CONTRACT CHANGE ORDER NO. _____
SHEET ____ OF ____

MARK	DATE	DESCRIPTIONS	BY	CH'D	CCO#
3	10/22/10	HINGE A BARRIER RAIL MODIFICATIONS	TH	GB	25S1
2	01/30/09	HINGE A BARRIER RAIL MODIFICATIONS	TH	AB	25S1
1	03/28/08	HINGE A BARRIER RAIL MODIFICATIONS	TH	AS	25S1

SAN FRANCISCO OAKLAND BAY BRIDGE
EAST SPAN SEISMIC SAFETY PROJECT
SELF-ANCHORED SUSPENSION BRIDGE
(SUPERSTRUCTURE & TOWER)

BARRIER DETAILS NO. 5

BARRIER DETAILS NO.5A

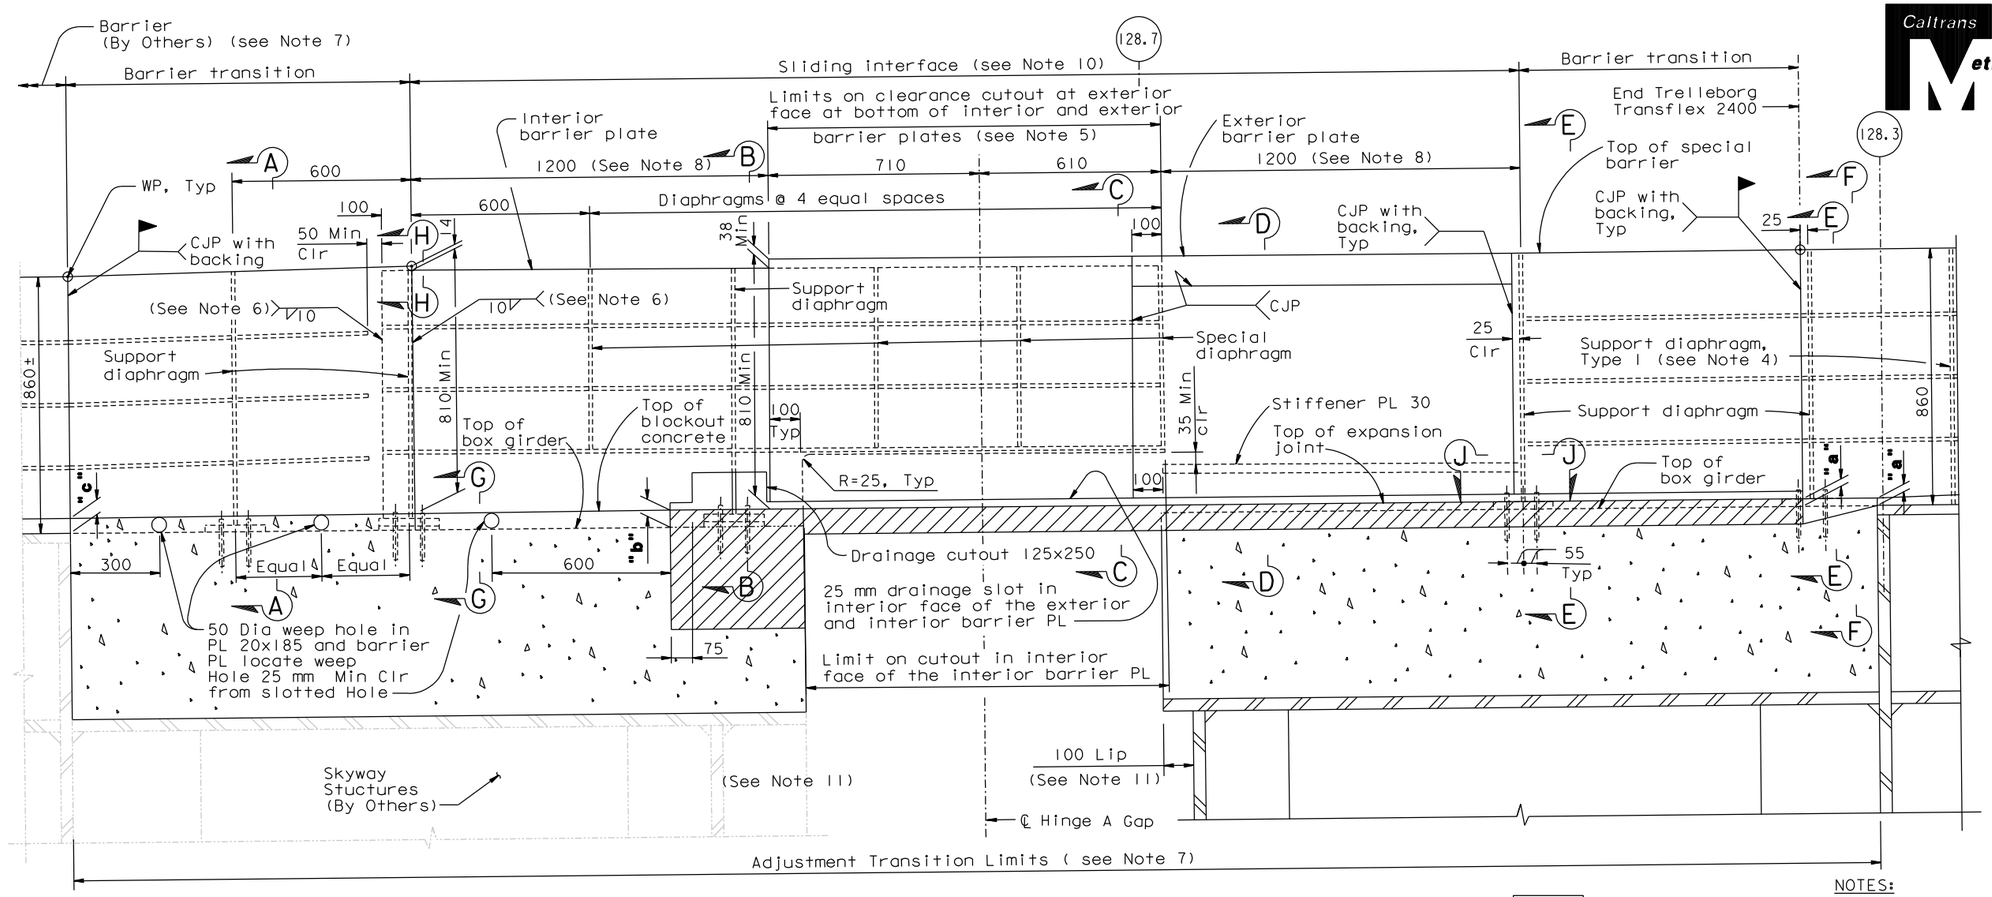
MARK	DATE	DESCRIPTIONS	BY	CH'D	CCO#
0	10/22/10	HINGE A BARRIER RAIL MODIFICATIONS	TH	GB	25S1

BARRIER DETAILS NO. 6

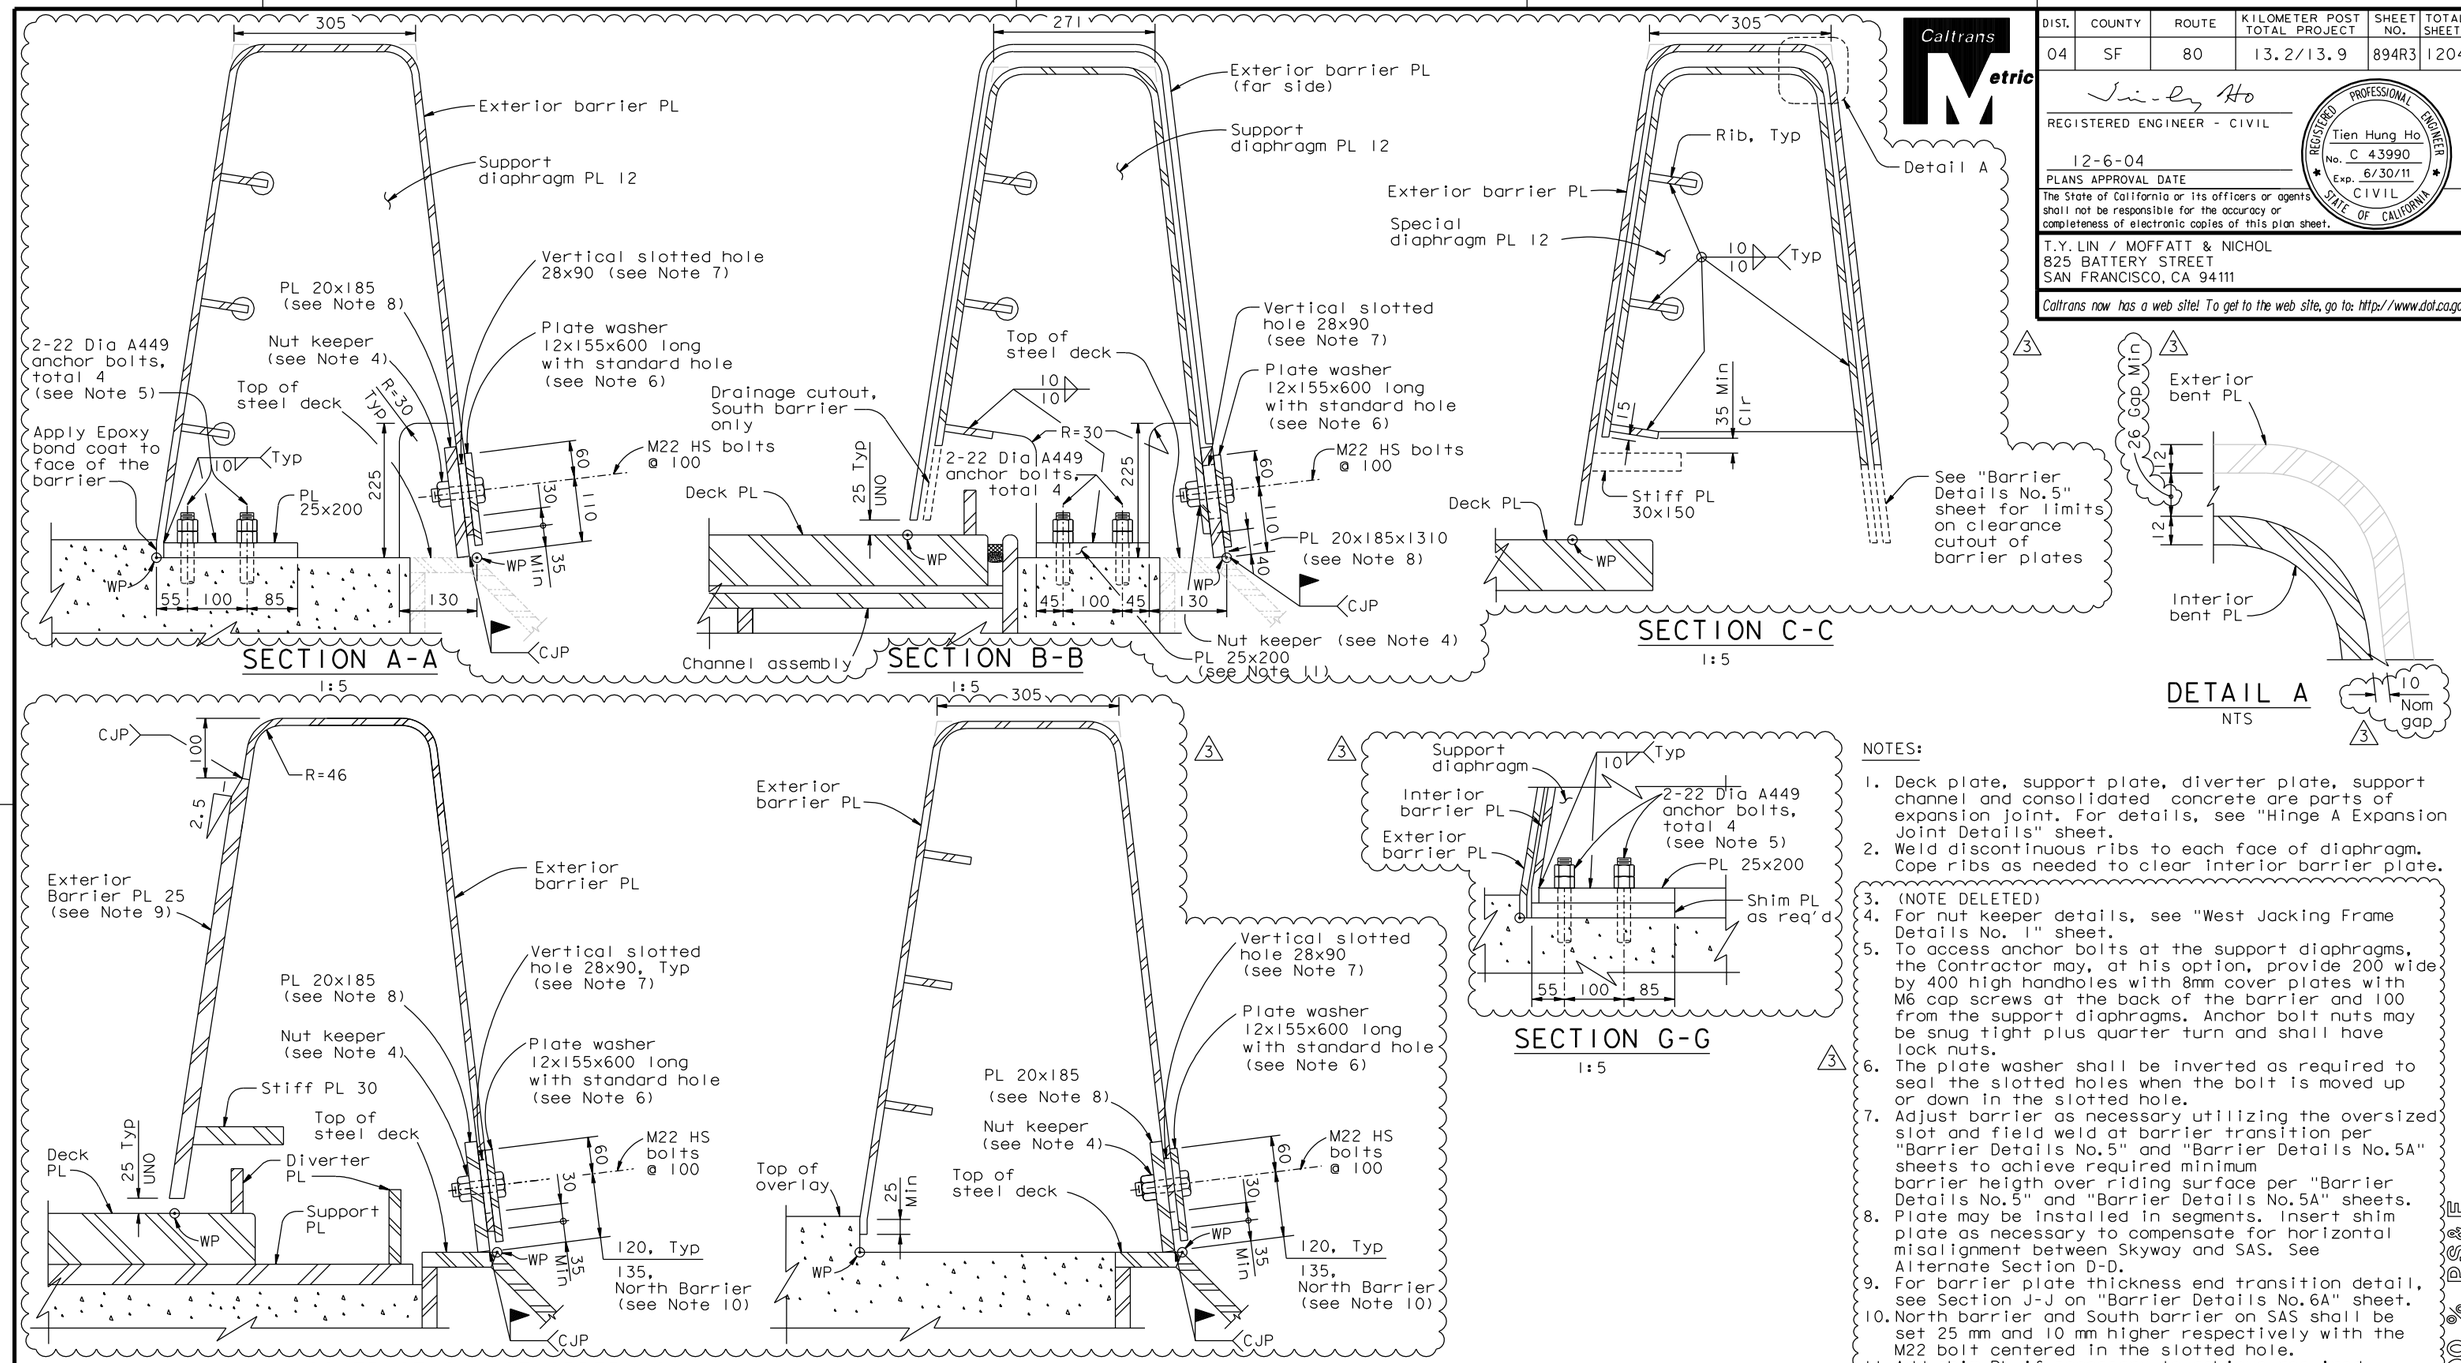
MARK	DATE	DESCRIPTIONS	BY	CH'D	CCO#
3	10/22/10	HINGE A BARRIER RAIL MODIFICATIONS	TH	GB	25SI
2	01/30/09	HINGE A BARRIER RAIL MODIFICATIONS	TH	AB	25SI
1	03/28/08	HINGE A BARRIER RAIL MODIFICATIONS	TH	AS	25SI

9. For barrier plate thickness end transition detail, see Section J-J on "Barrier Details No.6A" sheet.
10. North barrier and South barrier on SAS shall be set 25 mm and 10 mm higher respectively with the M22 bolt centered in the slotted hole.

11. Add shim PL if necessary to achieve required barrier height.

BARRIER DETAILS NO.6A

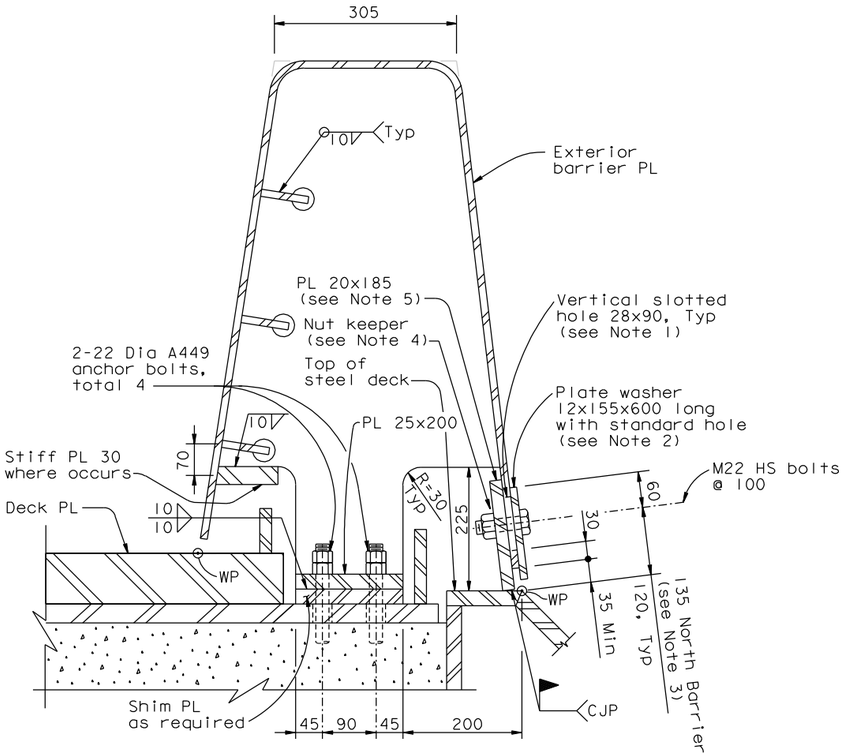
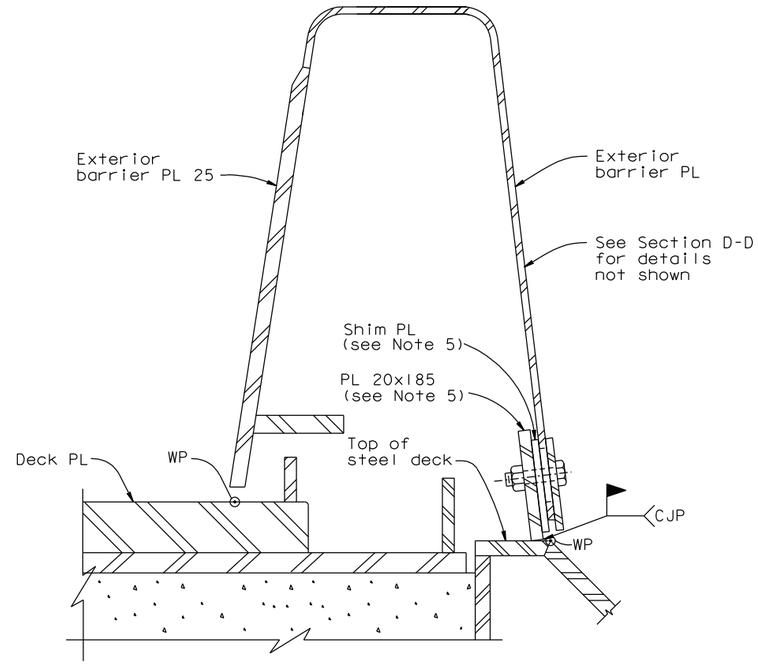
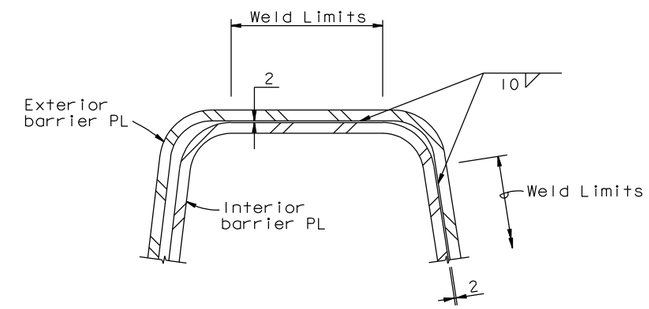
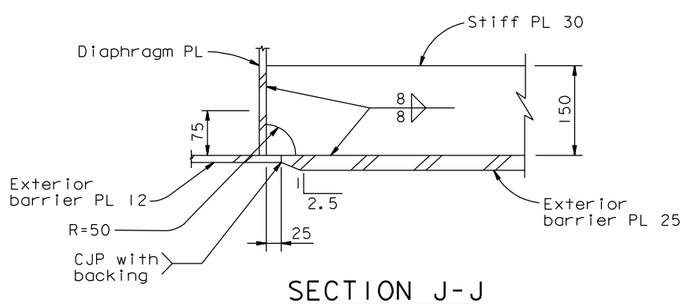
MARK	DATE	DESCRIPTIONS	BY	CH'D	CCO#
0	10/22/10	HINGE A BARRIER RAIL MODIFICATIONS	TH	GB	25S1

1. Adjust barrier as necessary utilizing the oversized slot and field weld to achieve required minimum barrier height over riding surface per "Barrier Details No.5" and "Barrier Details No.5A" Sheets.
2. The plate washer shall be inverted as required to seal the slotted holes when the bolt is moved up or down in the slotted hole.
3. North barrier and South barrier on SAS shall be set 25 mm and 10 mm higher respectively with the M22 bolt centered in the slotted hole.
4. For nut keeper details, see "West Jacking Frame Details No.1" sheet.
5. Plate may be installed in segments. Insert shim plate as necessary to compensate for horizontal misalignment between Skyway and SAS.
